## Technical Memorandum

**TO:** Mr. Alan Day, General Manager  
Brazos Valley Groundwater Conservation District

**SUBJECT:** Hydrogeologic Review of Transport Permit Applications for Mr. James Brien, Cula d’Brazos LLC, Ely Family Partnership LP, Fazzino Investments LP, RH2O LLC, Mr. Clifford A. Skiles III, and L. Wiese Moore LLC

Figure 2. AGS This Analytical Simulated Drawdown After Proposed L. Wiese Moore LLC Pumping of 4,452 ac-ft/yr for 10-Years

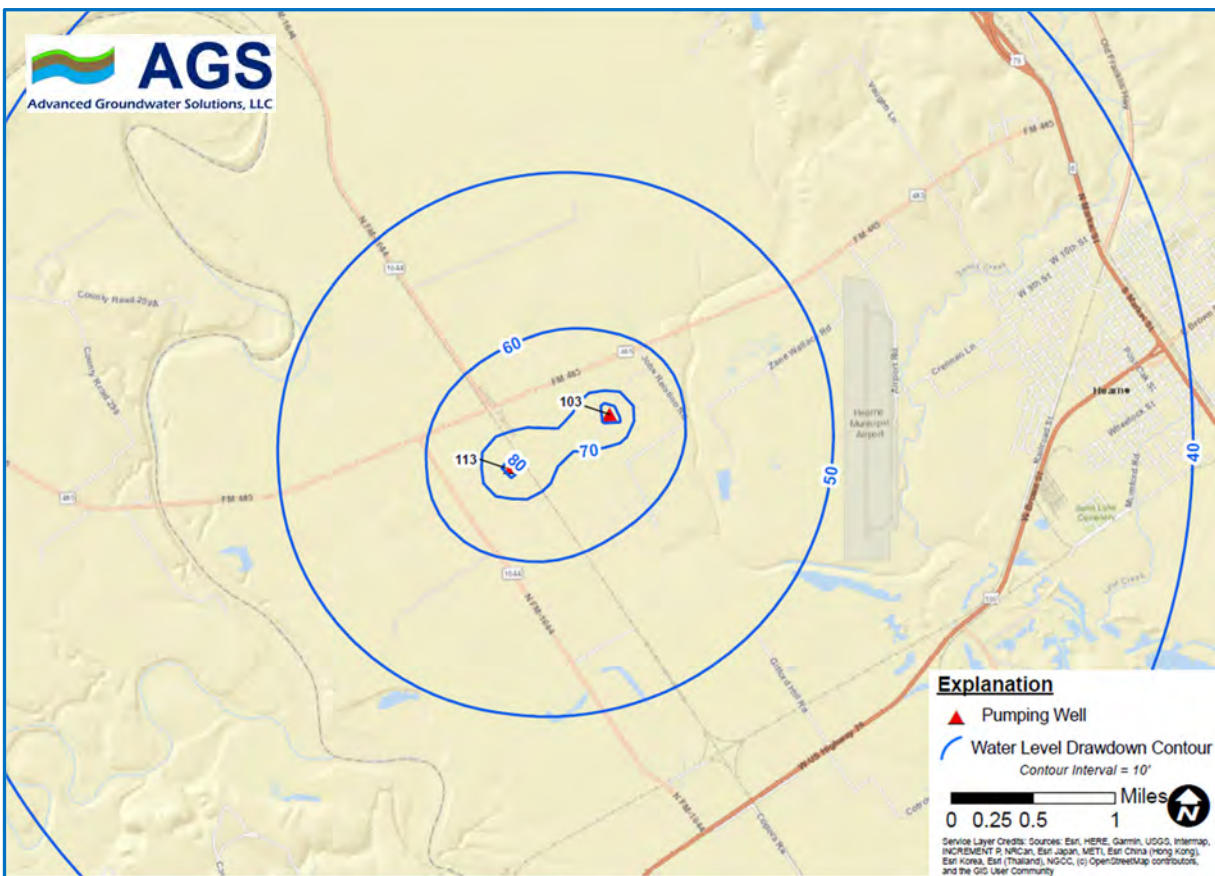
AGS was able to generally recreate the 1-year simulation results of the TGI analytical modeling. The TGI 10-year analytical simulation appears to underestimate the drawdown compared to simulations performed by AGS using the aquifer parameters as described above. Simulated drawdown could be less if TGI used a larger storage value in the 10-year simulation. Figure 2 below shows the estimated AGS analytical modeling drawdown contours that result from pumping 4,452 ac-ft/yr for 10-years.
